E5070B-08D

S E R V I C E N O T E

E5070B ENA Series Network Analyzer, 300 kHz to 3 GHz

Figure 1. Trace shows noise around 1.3 GHz to 2.1 GHz at preset setting.

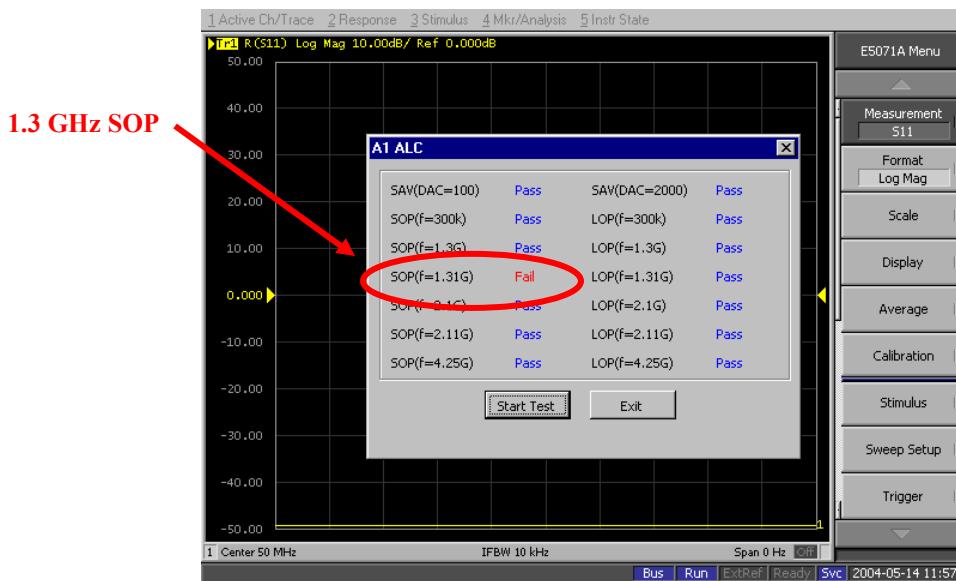
- The trace shows spike at 1.3 GHz or 2.1 GHz at the preset situation.
- The trace between 1.3 GHz to 2.1 GHz is more noisy than other frequency ranges.
- The power level of 1.3 GHz to 2.1 GHz is lower than other frequency ranges.
- Internal test of A1 ALC shows fail at SOP (f=1.3G) or LOP (f=1.3G) as Figure 2.

Above symptoms tend to appear after 30-minute heat run.

Replace the defective board with E5071-6x571, new A1 module. Also, update the operating system in accordance with the service note E5070B-10A to implement the firmware revision 5.00 or later. *1
